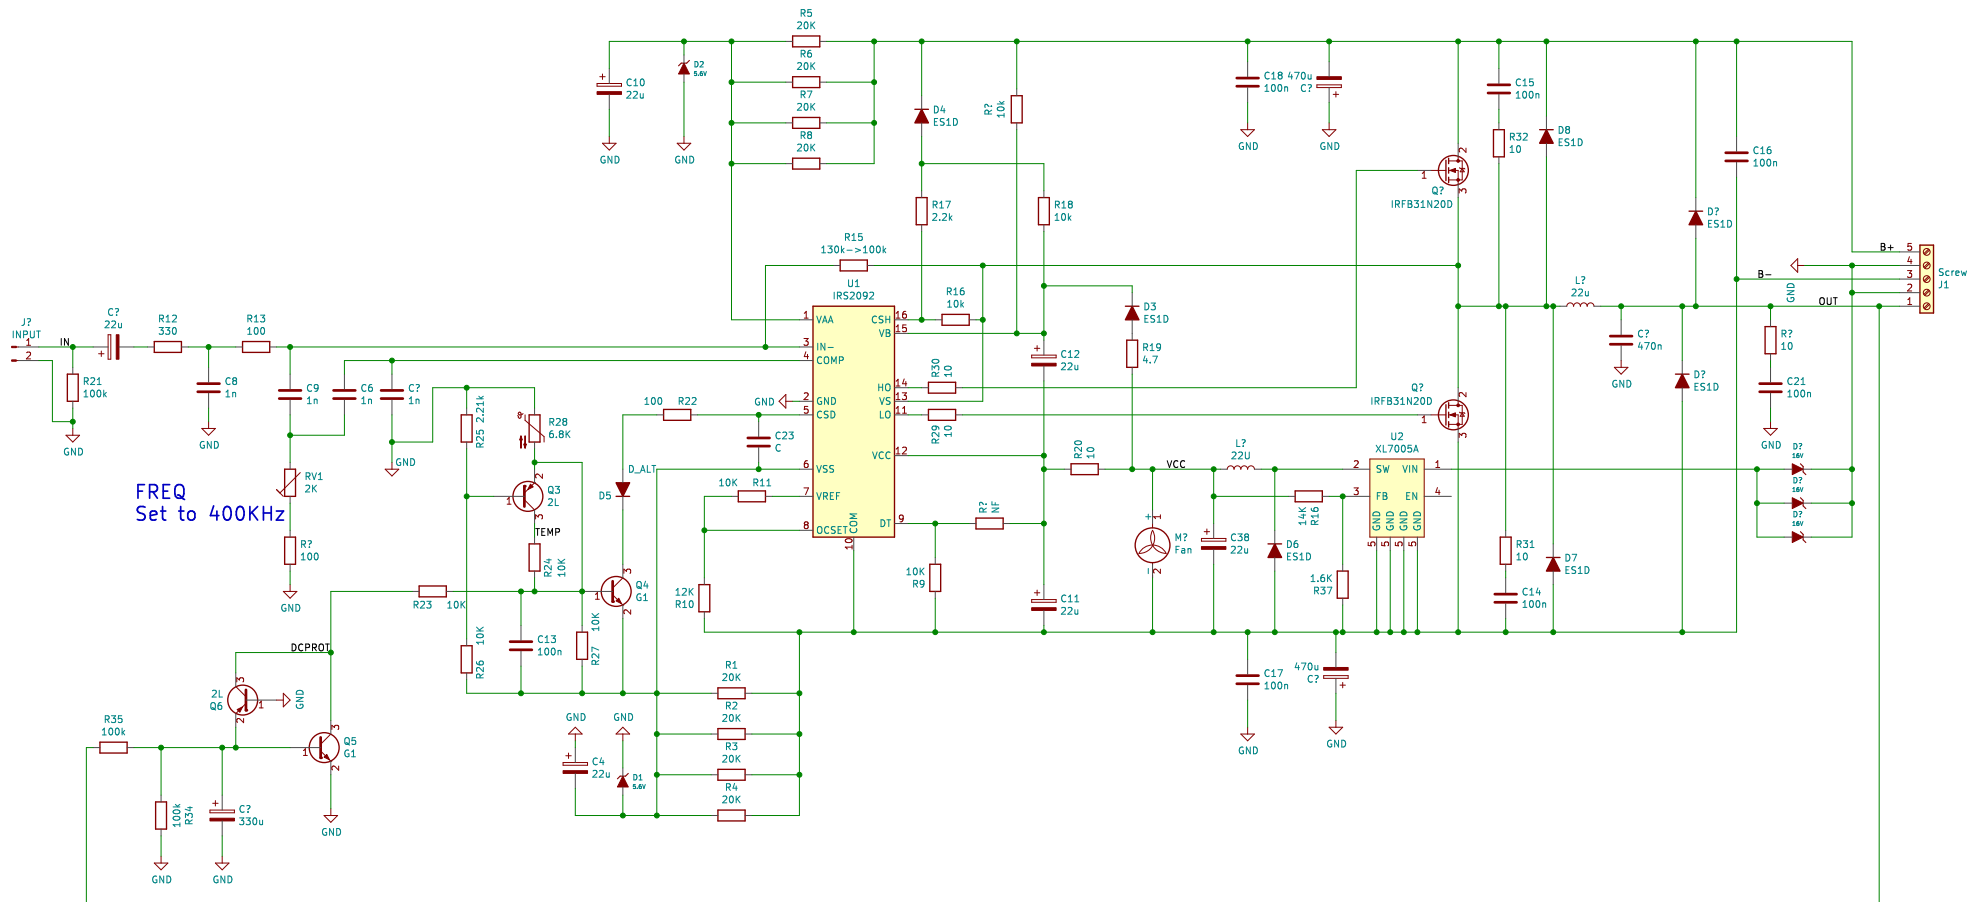
Changes from original:
R13 to 3.01K to set gain and stability
R11 to 8.2K for symmetrical current limiting
